# SERVICE BULLETIN

No. 399

Subject: Ignition System for High Altitude Operation; reference attached Avco Lycoming Service Instruction No. 1291, dated November 2, 1973.

Service Instruction No. 1291  
Engineering Aspects are  
FAA (DEER) Approved

Figure 1. Air Inlet Housing Showing Location for Drilling

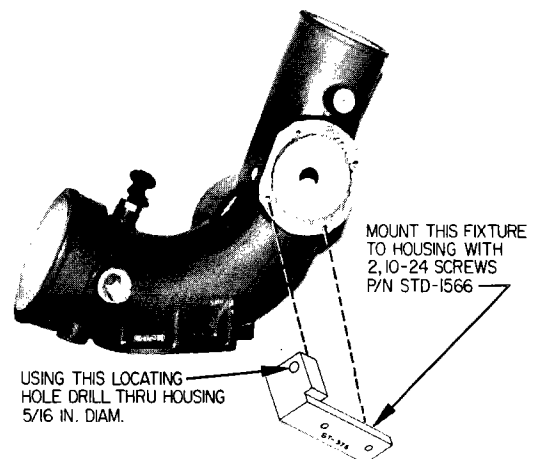
3. TIO-540-J2BD engines with serial numbers L-2751-61A thru L-2760-61A, L-2771-61A thru L-2773-61A, L-2780-61A, L-2782-61A thru L-2784-61A and LTIO-540-J2BD engines with serial numbers L-202-68A thru L-217-68A were manufactured with the hole drilled, tapped and plugged at the location shown in figure 1. Inspect the air inlet housing for the tapped 3/8-16 hole, if present remove bolt STD-1947, lockwasher STD-697 and washer STD-33. Proceed to step 13 for the installation of magneto pressure adapter.

7. Locate the drill fixture, ST-373 on the lower two mounting holes of pressure controlled pad with two STD-1566 (10-24) screws, so that the hole to be drilled is on the inside curve of the air inlet housing. See figure 1.

8. Using a hand drill and 5/16 drill bit, drill through one side of air inlet housing.

9. Remove drill fixture and hand counterbore the drilled hole to a maximum depth of .09/.13 inch x .390 in. dia.

10. Tap hole with 3/8-16 tap.

Figure 2. Top View of Engine Showing Details for Pressurized Magneto Installation

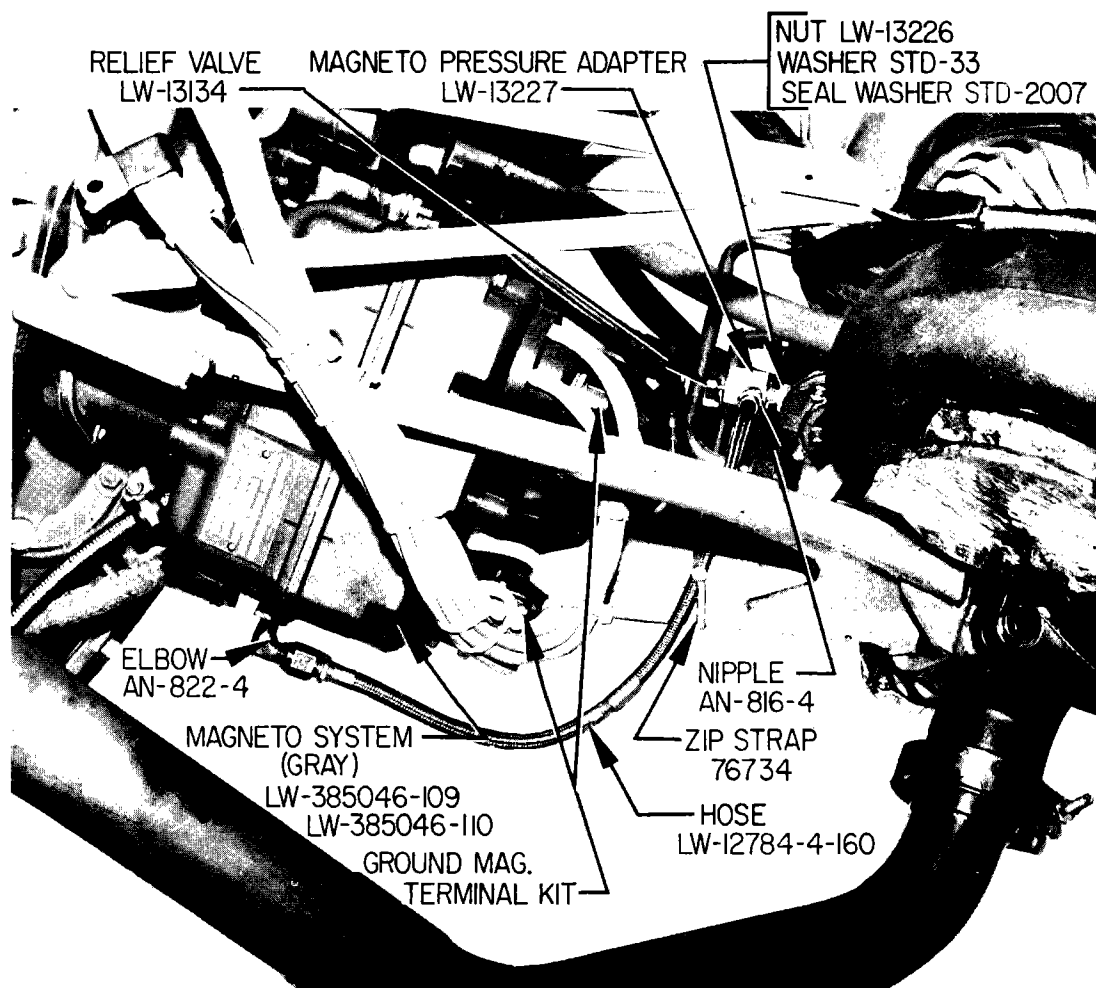
13. Install AN-822-4 elbow in left side of magneto.

14. Install relief valve LW-13134 using MS29512-04 o-ring in adapter and safety wire, also, install nipple AN-814-4.

15. Install relief valve adapter LW-13227 using LW-13226 plain nut (.375-16), STD-33 plain washer, and STD-2007 seal washer in 3/8-16 hole. Position the adapter with nipple AN-814-4 toward the pressure controller mounting pad, tighten nut LW-13226. Reinstall the pressure controller on the inlet housing.

16. Install hose LW-12784-4-160 between elbow AN-822-4 in magneto and nipple AN-814-4 in relief

valve adapter. Fasten hose to lower strut of turbo-charger bracket with zip strap 76734.
